**PLANNING APPROVAL,
PLANNED UNIT DEVELOPMENT &
SUBDIVISION STAFF REPORT****Date: December 3, 2015**

<u>NAME</u>	Inner Peace Subdivision
<u>SUBDIVISION NAME</u>	Inner Peace Subdivision
<u>LOCATION</u>	2354 & 2410 Eloong Drive (East terminus of Eloong Drive)
<u>CITY COUNCIL DISTRICT</u>	District 3
<u>PRESENT ZONING</u>	R-1, Single-Family Residence District
<u>AREA OF PROPERTY</u>	1 Lot / 6.72± Acres
<u>CONTEMPLATED USE</u>	Planning Approval to allow a meditation center in an R-1, Single-Family Residential District, Planned Unit Development approval to allow multiple buildings on a single building site, and Subdivision approval to create one legal lot of record.
<u>TIME SCHEDULE FOR DEVELOPMENT</u>	None provided

SITE PLAN

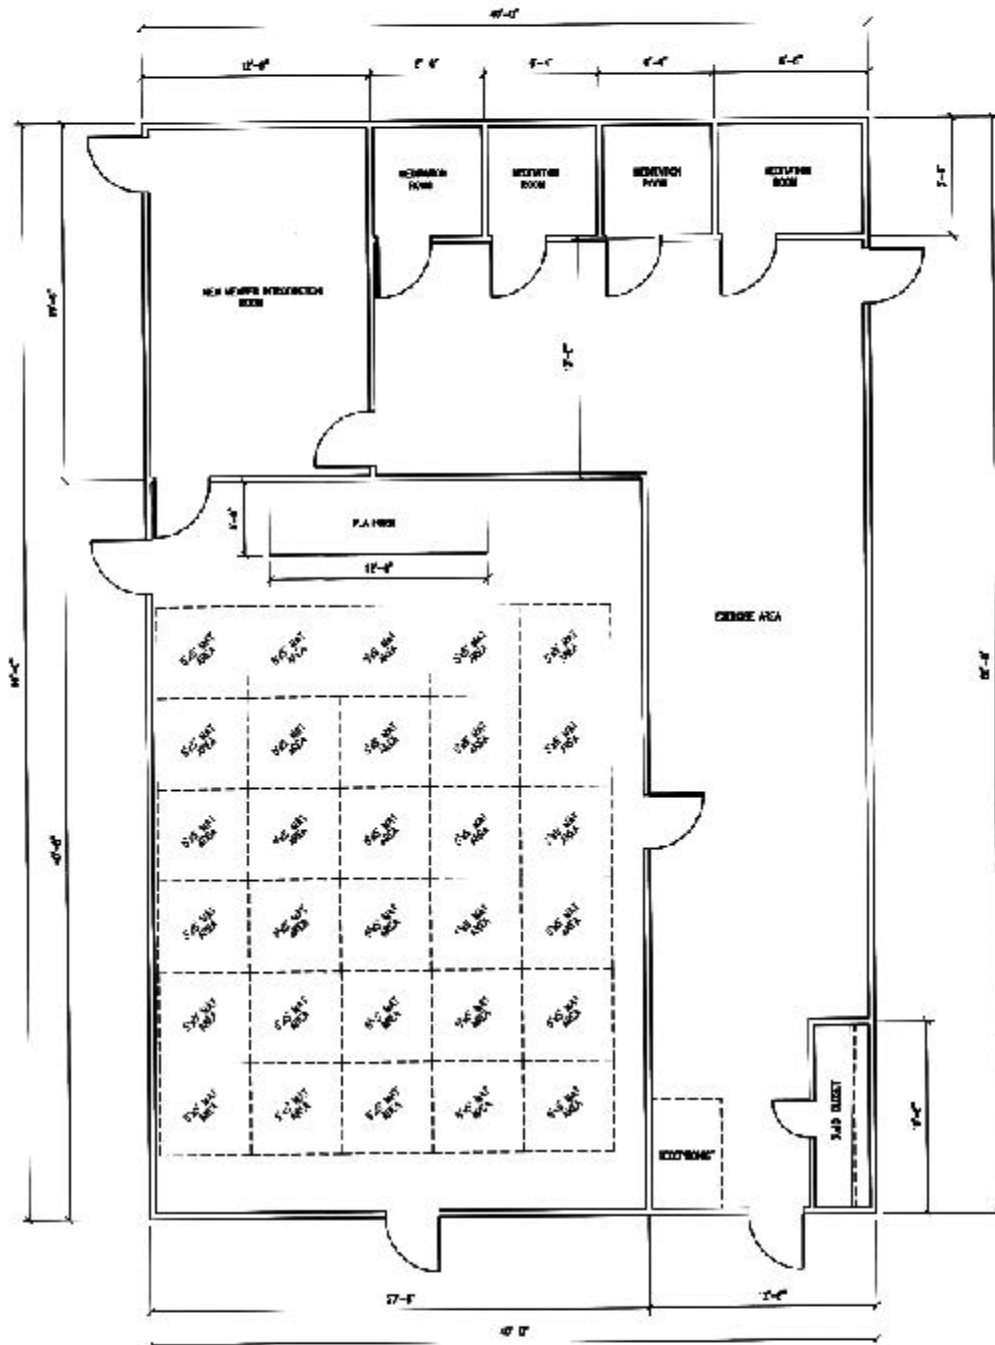
The site plan illustrates existing asphalt driveways and an existing gravel driveway on the site, however it should be noted that none of the existing driveways meet the minimum required width of 24' for two-way traffic. The applicant has submitted a variance application to allow the use of gravel surfacing which will be heard at the Board of Zoning Adjustment's November 2, 2015 meeting. Per Fire Department comments, the site plan should be revised to reflect 26' wide driveways paved with asphalt or concrete, unless the surfacing variance is approved.

Because the site is transitioning from a residential use to a commercial use, the site should be required to fully comply with all landscaping and tree planting requirements. The site plan indicates that the site will have ample amounts of landscape area; however no trees are illustrated on the site plan. The applicant states that there are 24" or larger trees on the site; but none of them are illustrated on the site plan. The site plan should be revised to reflect this requirement, if approved.

The site plan depicts a 10' wide vegetated residential buffer around the perimeter of the site, but as none of the existing vegetation is illustrated on the site plan, staff is unable to verify if this buffer is adequate to comply with Section 64-4.D.1. of the Zoning Ordinance.

The site plan provides parking calculations stating that parking will be provided for 8 dwelling units, and a 1 parking space per 100 square feet ratio was used to determine parking required for the meditation center. It should be noted that because of the religious nature of the proposed facility, the parking requirements should be based on the occupancy of the structure. If the structure will have a total occupancy load of more than 50 individuals (excluding hallways and bathrooms), the International Building Code classifies the proposed use as assembly. To determine the amount of required parking, the applicant should provide a floor plan of the proposed 2,400 square foot meditation center. The floor plan should illustrate restrooms and hallways, and their square footage. It should also illustrate areas used for meditation and if there will be fixed seating (or designated space per person), or standing room. Even though the applicant may anticipate only 30 individuals at one time, since the approvals are for the use and the site, not a particular entity, the staff and Planning Commission should also consider that another entity with higher attendance may occupy the property at some future date. Therefore, calculations should be based on maximum capacity or occupancy load. Based on the number of proposed parking spaces, the applicant will be required to submit a photometric site plan at the time of permitting to insure that the site will comply with the requirements of 64-6.A.8. of the Zoning Ordinance.

No dumpsters are illustrated on the site plan, nor is a note stating the site will use curb-side pickup. It should be noted that any dumpsters on site should be connected to sanitary sewer and have a dumpster enclosure compliant with Section 64-4.D.9. of the Zoning Ordinance.

Most of the revisions required by the holdover were addressed. However, the driveway was only modified to a 20' width from the street entrance to the parking area for the two proposed cottages or about 240' into the site. For the remainder of the driveway, approximately 80' is proposed to remain gravel, and the remaining 330'± to be the existing asphalt. However, the existing 10' width is proposed for this 410' stretch, well below the 26' required by the Fire Department.
